GRIFFEY ENGINEERING, INC.

March 10, 2025
Lake Hills – Main Boulevard & Mass Grading
Engineering Review Comments
Page 1

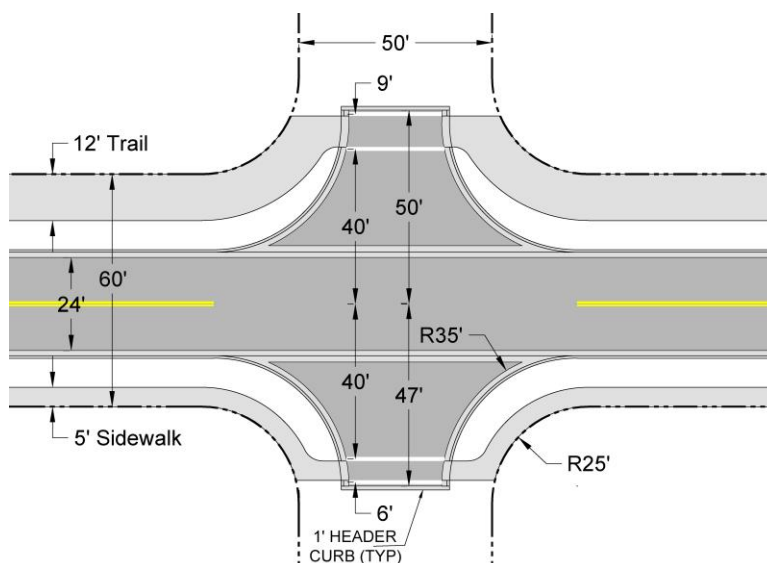
The construction of the side streets along the boulevard should be built with a full turnout as depicted below. Adjust the plans to reflect that configuration.
